# Administrative Approval Action

**S-42-18 /Century Drive Hotel Subdivision  
Transaction# 566600 AA#3905**

## PRELIMINARY SUBDIVISION PLAN CITY OF RALEIGH TRANSACTION #566600 CITY OF RALEIGH CASE #S-42-18 BOARD OF ADJUSTMENT VARIANCE #A-31-18

### PROPOSED LANDSCAPE PLAN

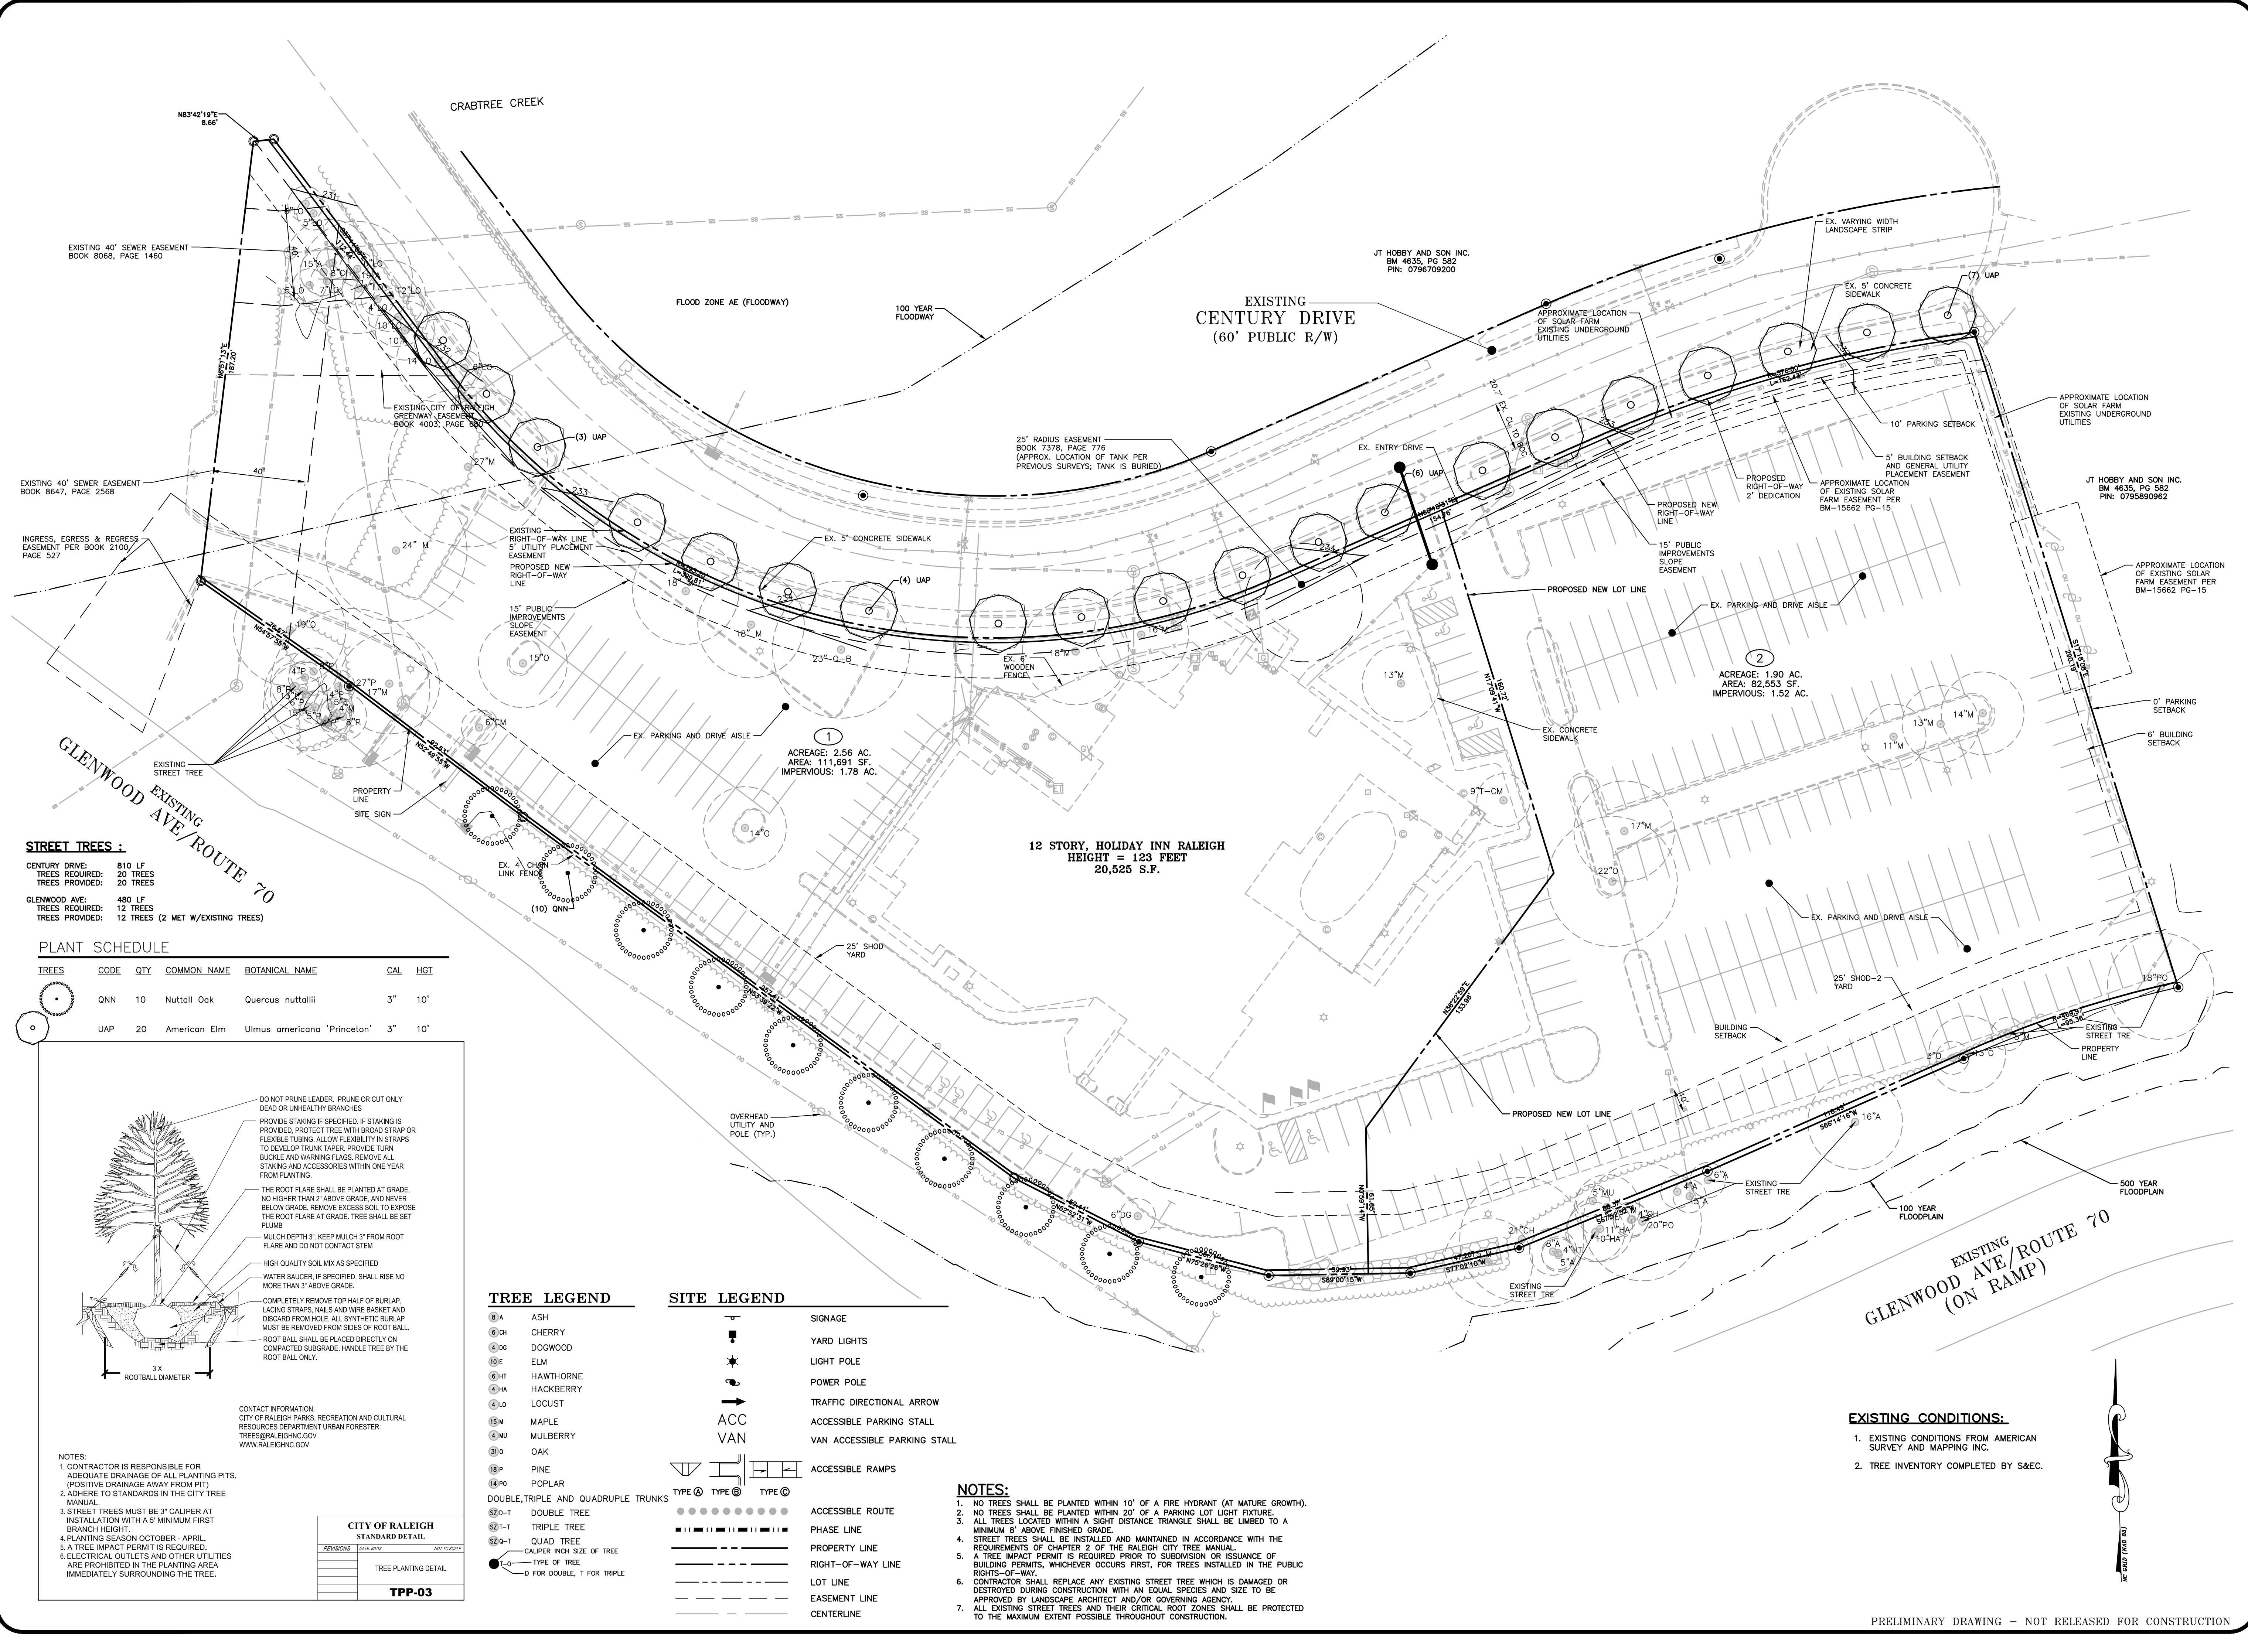
- A tree impact permit must be obtained for the approved streetscape tree installation in the right of way. This development proposes 10 new shade trees and 4 existing shade street trees along Glenwood Avenue and 20 new shade trees along Century Drive.
